Bid 17-22 2017 Construction of Wheelchair Ramps and Sidewalks - Various Locations

Addendum #1 Contractor Question Responses

FIGURE #2

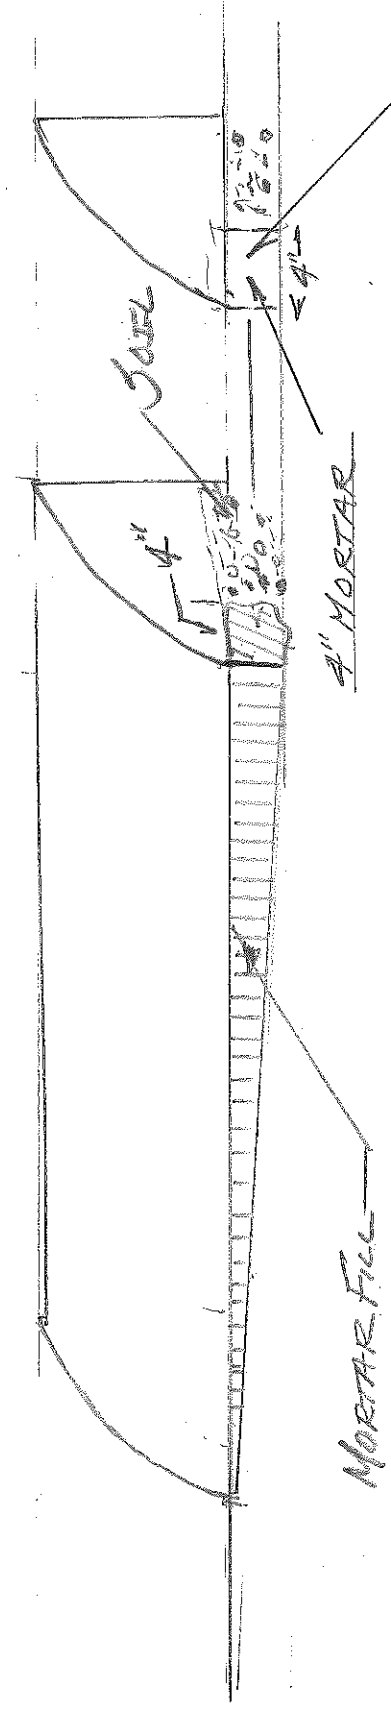
3. **Q: Item #26 on pg.9, MORTAR BENEATH THUMB WALLS, What is meant by 4" of mortar.**

A. Remove soil between the bottom of thumb wall and the new sidewalk to a minimum of 4" under the thumb wall, then replace with mortar. See figure #2 & #3.
